# Mendon Telecommunications Facility

## Aesthetic Assessment & Orderly Development Review

PUC Case #: 20-1149-PET

Prepared For: Vermont Department of Public Service

Tower Elevations from Exhibit AT&T 51

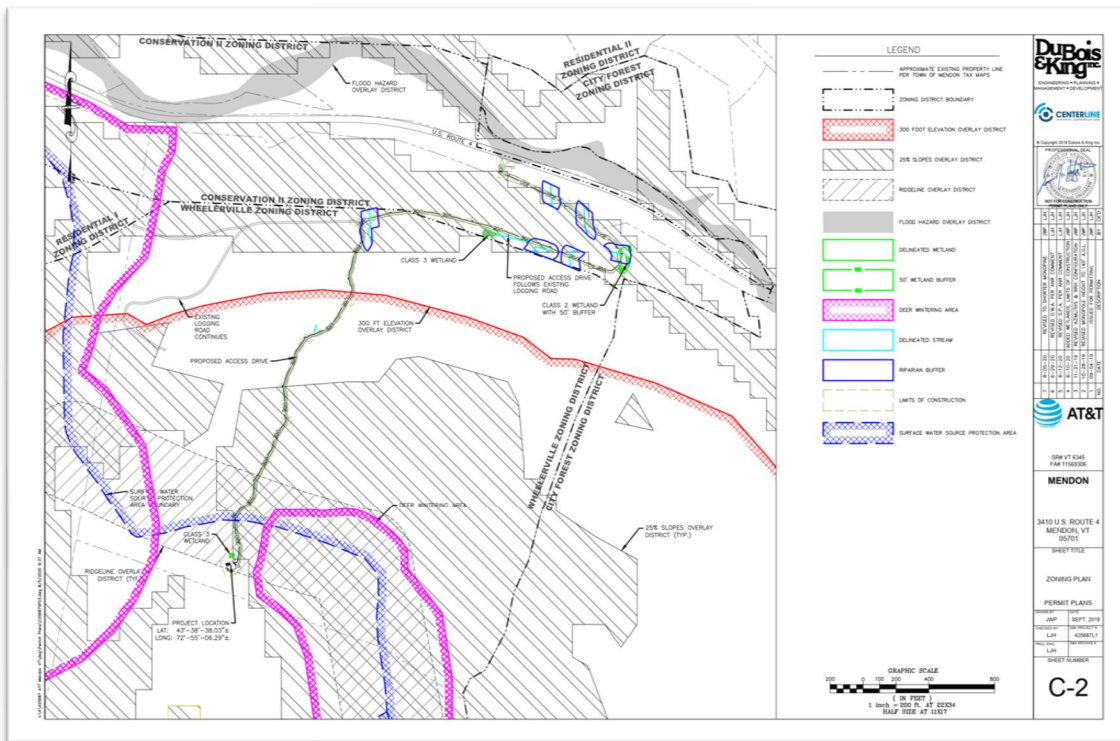
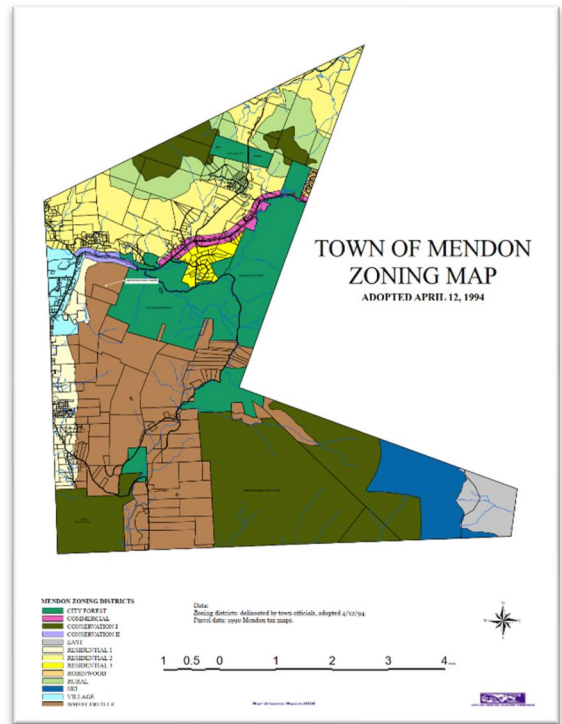
A stealth tapered support structure (sometimes called a "monopine") extending to a height of 89' above ground level.... with the six AT&T panel antennas and remote radioheads installed at a centerline height of 85' and topped with a stealth camouflaged "crown" extending to a total height of 96' AGL (the "Redesigned Tower").

The Project's new proposal for the Redesigned Tower of 96' AGL in overall height can be considered as more compatible with the Project's surroundings than the Original Tower that was 140' AGL, in that it is much closer in height to the surrounding tree line measured at 69.1' AGL. The Redesigned Tower height is proposed to be 89' AGL to the top of the monopole and 96' AGL to the top of the monopine stealth “branching.” With this proposal, the Redesigned Tower height will be approximately 20' taller than the surrounding tree canopy (to the top of the monopole) and 27' taller to the top of the monopine stealth “branching” to the “crown.” Inclusion of tapered “stealth” branching and a “crown” that will allow the Redesigned Tower to more effectively blend in with the surrounding landscape than the Original Tower.

As a telecommunication tower, the Tower structure needs to be taller than the surroundings to allow for the operational and functional use and will be, by design, at a greater vertical scale than its surroundings. The Applicant has greatly reduced the height of the Redesigned Tower from 140' AGL (Original Tower height) to 96' AGL total height (including the "crown"), which is approximately 27 feet taller than the existing surveyed tree line. The top of the monopole structure is proposed at 89' AGL, or approximately just under 20 feet taller than the existing surveyed tree line. The scale of the Redesigned Tower will be more compatible with the surroundings than a taller structure would be.

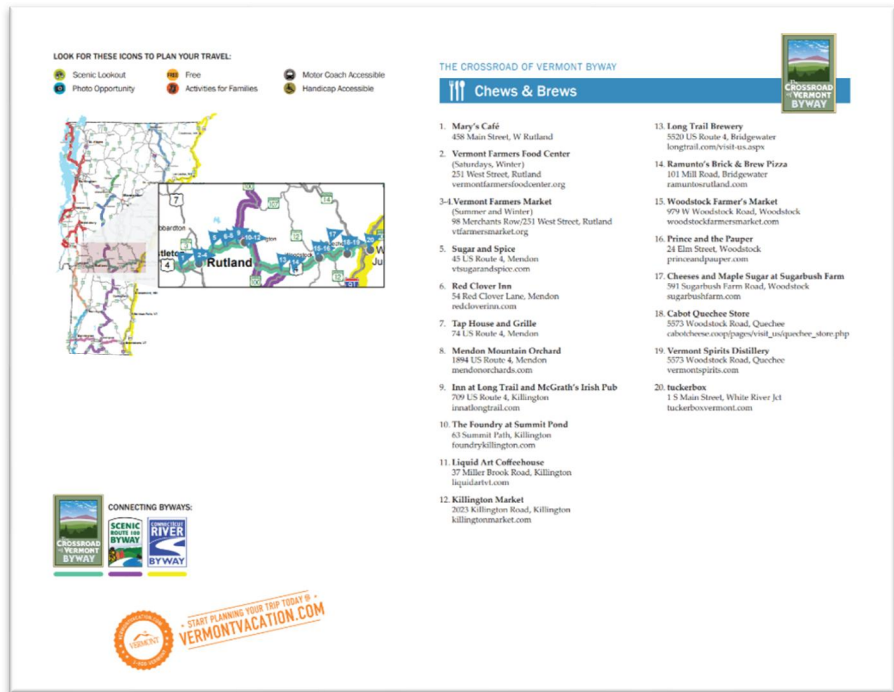
The Project parcel is wooded with mature deciduous and evergreen tree species. The Detailed Site Plan C-15 in *Exhibit AT&T 5I* catalogued (17) trees in or around the Project and Compound that included mostly deciduous species. The species mix found were oak, maple, birch, and one hemlock; the average height of these trees is calculated to be 69.1 feet.

The Zoning Bylaws *Regulation of Wireless Telecommunications Facilities*, Section 1.6 *Permitted and Prohibited Locations* states that "H. No tower may be erected which protrudes by more than twenty (20) feet above the average height of the surrounding trees." The average height of the tree line has been documented as 69.1 feet; the Redesigned Tower is proposed to be 89' AGL to the top of the monopole and appurtenances, with a total height of 96' AGL that includes non-essential stealth branching and camouflage materials. While the total height of the Redesigned Tower, including stealth and camouflaging elements, is approximately 7' taller than the 20' allowed in the Zoning Bylaws, the applicant has greatly reduced the height from the Original Tower, so all functional components of the Redesigned Tower will comply with the height limitations. As proposed, the Redesigned Tower does meet the Zoning Bylaws and the Town's *Regulations of Wireless Telecommunication Facilities*.
